Re: 2 Collegium Avenue, Wheelers Hill

Introduction

Proposed Scheme - Development Strategy by Rothelowman

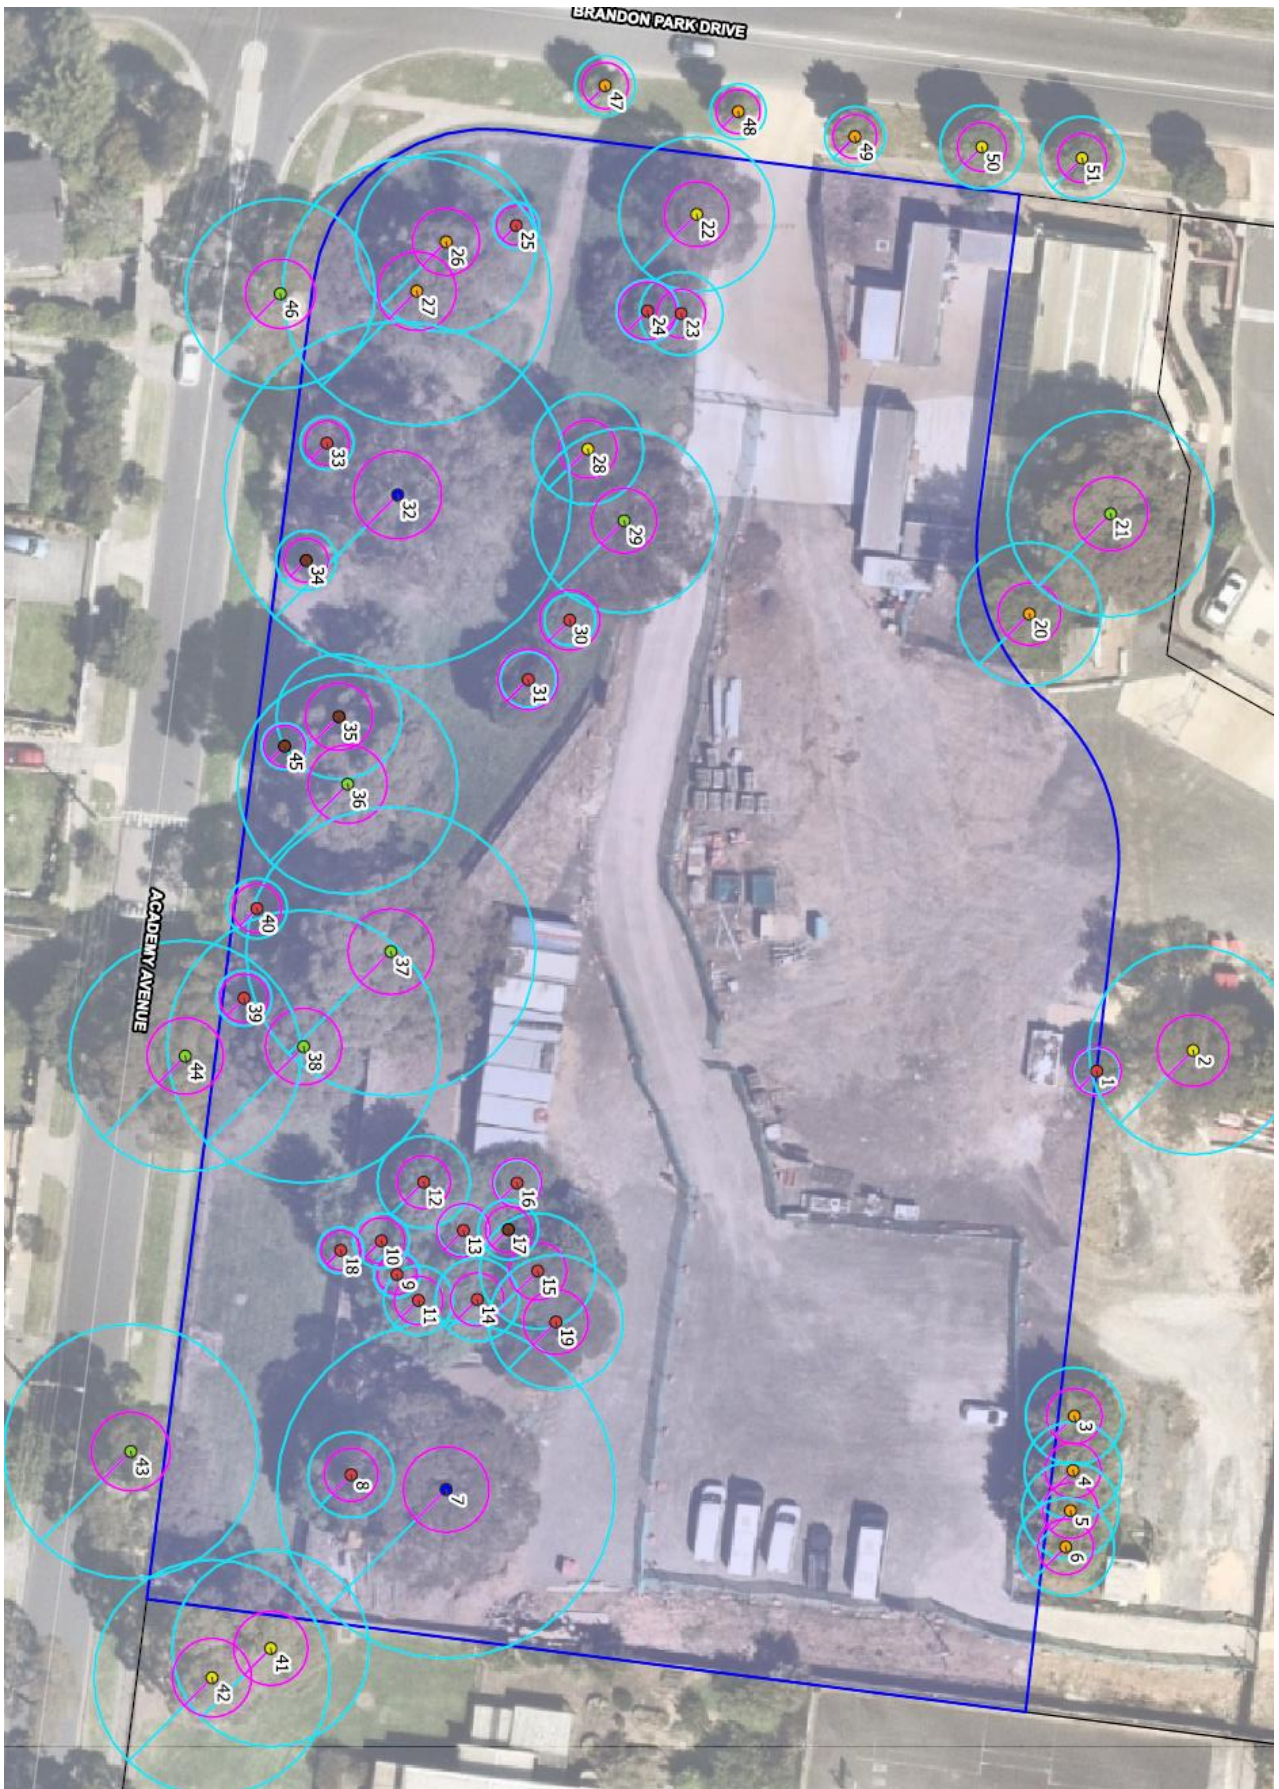
I inspected the trees on the 26/Sep/24. Each tree is numbered and located on the accompanying extract of the plan on page 2, taken from the Treelogic 2024 report. I have also perused the Development Strategy drawings by Rothelowman, dated 19/12/2024.

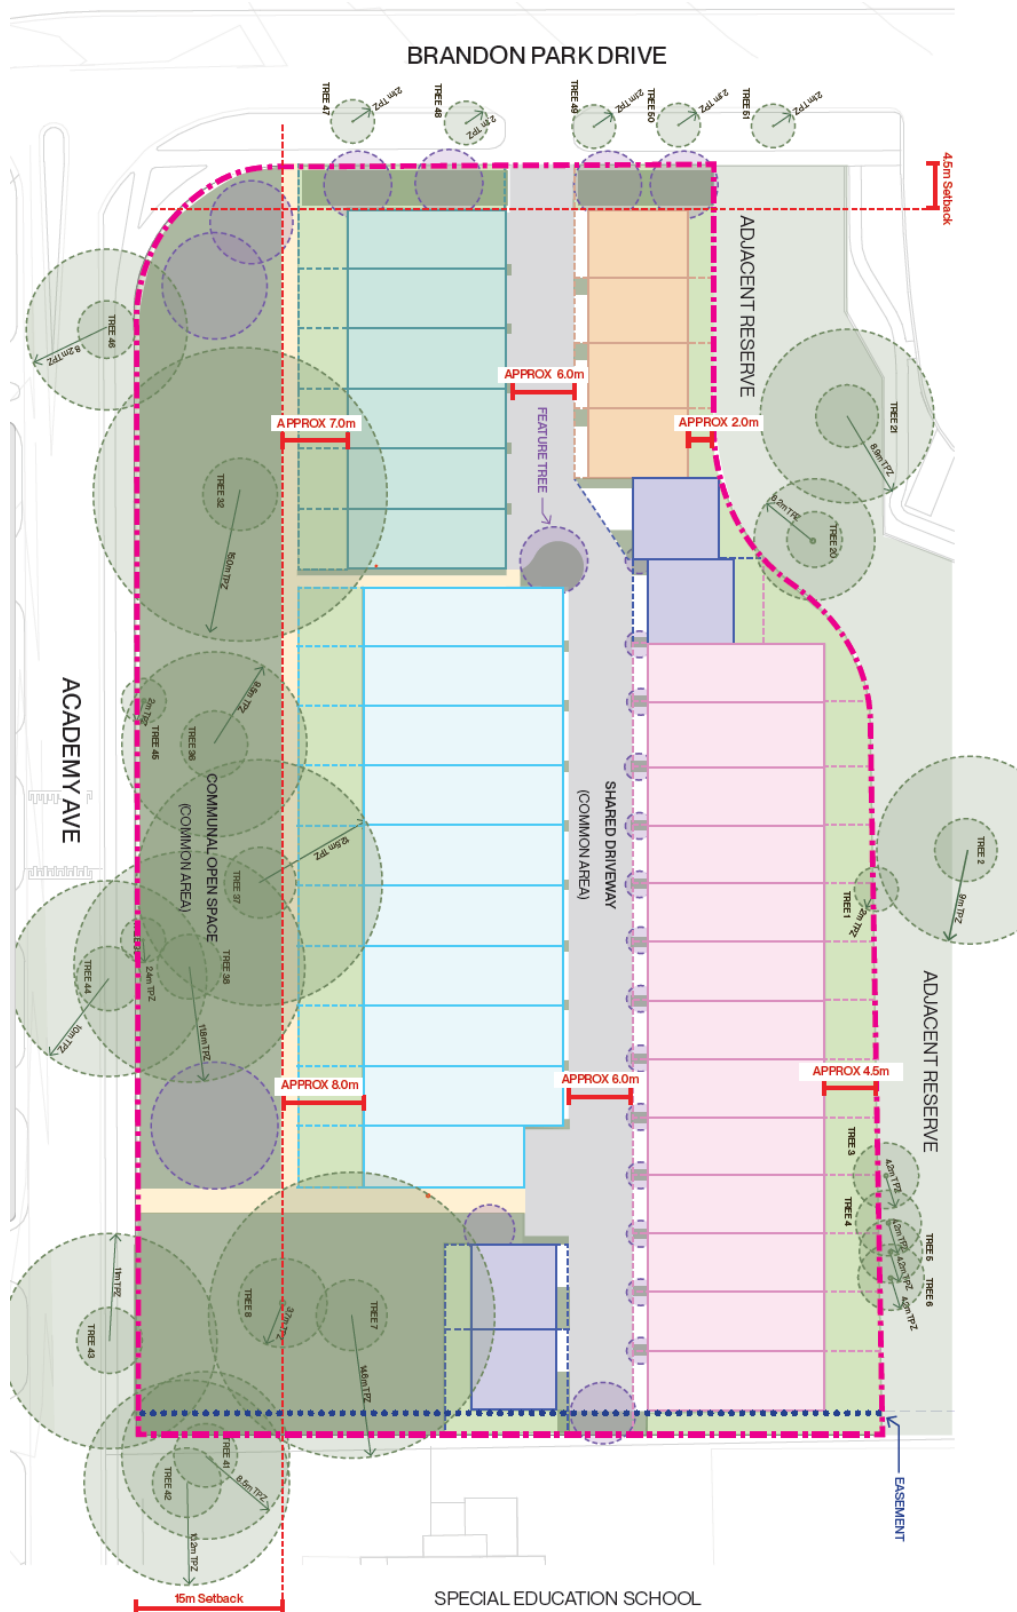
The current endorsed development plan (Council stamped 31 January 2017) informs the retention of Trees 7, 32, 36, 37 and 38 as part of the site's future re-development with other trees (those previously identified as 40, 112, 114, 115 and 166) as being removed from the site. According to the Development Strategy by Rothelowman it is apparent that Trees 7, 32, 36, 37, 38 and 39 can be satisfactorily retained, although some pruning back on the northerly sides of several of the trees will be required. Furthermore some of these trees are in poor condition such as tree 38, whilst 39 is way too close to the Academy Avenue footpath to be able to be retained for the medium to long term. As noted, the endorsed development plan already informs the removal of some trees, and inherent with the retention of noted trees 7, 32, 36, 37 and 38 will be the avoidance of addition of fill or excavation for level reductions or strip footings between the proposed buildings and retained trees. Any proposed footpaths where well within the TPZs will have to be constructed at grade. Similarly, any drains or services proposed well within the TPZs will have to be inserted in a manner which avoids significant root loss.

According to the plans, the trees proposed to be removed are numbers 9-19, 22-31 and 33-35. It should be noted that trees 9-17 and 19 have already been removed. With the exception of tree 29 which is a Yellow Gum in reasonable condition, all the other trees proposed for removal are either weeds or in poor condition.
